Project	IEEE 802.16 Broadband Wireless Access Working Group < http://ieee802.org/16 >	
Title	DL-MAP and UL-MAP CID Table IEs	
Date Submitted	2005-01-26	
	Mary Chion Sean Cai Jason Hou Jing Wang Dazi Feng Jun Han Irving Wang	mchion@ztesandiego.com scai@ztesandiego.com jhou@ztesandiego.com
	ZTE San Diego Inc. 10105 Pacific Heights Blvd. San Diego, CA 92121 USA	Voice: 858-554-0387 Fax: 858-554-0894
Re:	Response to Sponsor Ballot on IEEE802.16e/D5a document	
Abstract	The proposed DL-MAP and UL-MAP CID table IEs can be used to not only improve DL subframe efficiency but also significantly reduce unnecessary power consumption.	
Purpose	To incorporate the text changes proposed in this contribution into the 802.16e/D6 draft.	
Notice	This document has been prepared to assist IEEE 802.16. It is offered as a basis for discussion and is not binding on the contributing individual(s) or organization(s). The material in this document is subject to change in form and content after further study. The contributor(s) reserve(s) the right to add, amend or withdraw material contained herein.

DL-MAP and UL-MAP CID Table IEs

3. Specific Text Changes

Figure 208c. Association for DL-MAP CID Records and DL/UL MAP Data Burst Allocation

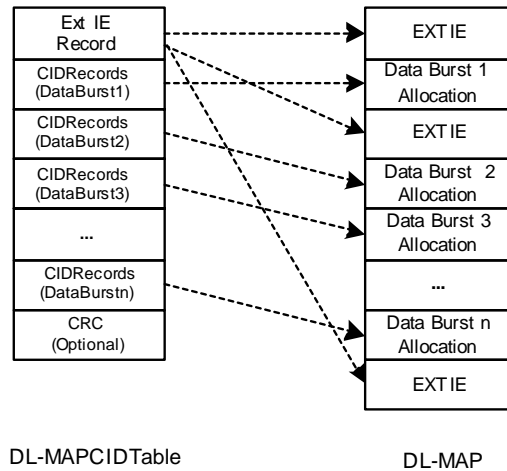
8.4.5.3.20 DL-MAP CID table IE

The association of DL-MAP CID table IE records and DL_MAP allocations are shown in Figure 208c.

Table 284k—DL-MAP CID Table IE

Syntax	Size	Notes
DL-MAP CID table IE () {		
<u>Extended DIUC</u>	<u>4 bits</u>	<u>0x??</u>
<u>Length</u>	<u>4 bits</u>	<u>Length in bytes of following fields</u>
<u>CID Table Sequence</u>	<u>2 bits</u>	<u>00: First page</u> <u>01: Middle page</u> <u>10: Last page</u> <u>11: Single Page</u>
<u>If ("CID Table Sequence" = "00")</u>		
<u>{</u>		
<u> CID Format</u>	<u>2 bits</u>	<u>00: 16 bits</u> <u>01: 12 bits LSB</u> <u>10: 8 bits LSB</u> <u>11: 4 bits LSB</u>
<u> H-ARQ MAP INC</u>	<u>1 bits</u>	<u>0: H-ARQ MAP Pointer IE not included in DL_MAP</u> <u>1: H-ARQ MAP Pointer IE included In DL_MAP</u>
<u> MBS MAP INC</u>	<u>1 bits</u>	<u>0: MBS Service MAP IE not included in DL_MAP</u> <u>1: MBA Service MAP IE included in DL_MAP</u>
<u>}</u>		
<u>Begin CID records</u>		<u>Each CID record contains the list of CIDs. Two types of CID records:</u> <u>Normal CID Record: Each normal CID record contains a list of CID that is corresponding to a allocated data burst in DL_MAP</u> <u>Extended CID Record: Only one extended CID record, it contains the all CIDs that can be</u>

<u>included in extended IE.</u>
<u>for (i=0; i<n; i++)</u>		<u>0 to n records can be included in a DL_MAP_CID Table IE. n doesn't need to be defined, it can be deducted based on length field</u>
<u>{</u>		
<u> Broadcast Burst</u>	<u>1 bit</u>	<u>0: not a broadcast burst 1: broadcast burst</u>
<u> If (Broadcast Burst = 0)</u>		<u>Number of CIDs left from the last CID Table</u>
<u> {</u>		
<u> Record Type</u>	<u>1 bit</u>	<u>0: Normal CID Record 1: Extended IE CID Record</u>
<u> Continuation Flag</u>	<u>1 bit</u>	<u>0: This record will not be continued 1: This record will be continued in the first record of next IE</u>
<u> NUM CIDs</u>	<u>6 bits</u>	<u>Number of CIDs in this record</u>
<u> for (i=0; j < NUM CIDs; j++)</u>		
<u> {</u>		
<u> CID</u>	<u>N bits</u>	<u>N = 16 when "CID Format" = "00" N = 12 LSB when "CID Format" = "01" N = 8 when "CID Format" = "10" N = 6 when "CID Format" = "11"</u>
<u> } //end for-loop NUM CIDs</u>

<u> } //if !broadcast burst</u>		
<u>}</u>		
<u>If ("CID Table Sequence" = "10" or = "11")</u>		
<u>{</u>		
<u> CRC INC</u>	<u>1</u>	<u>0: CRC is not included 1: CRC is included</u>
<u> CRC</u>	<u>32 bits</u>	<u>CRC-32 calculation for the DL-MAP CID Table IE (including all pages) is the same as that used for standard MAC messages</u>
<u>}</u>		
<u>Padding bits</u>	<u>Variable</u>	<u>Set to zeros to align octet boundary</u>
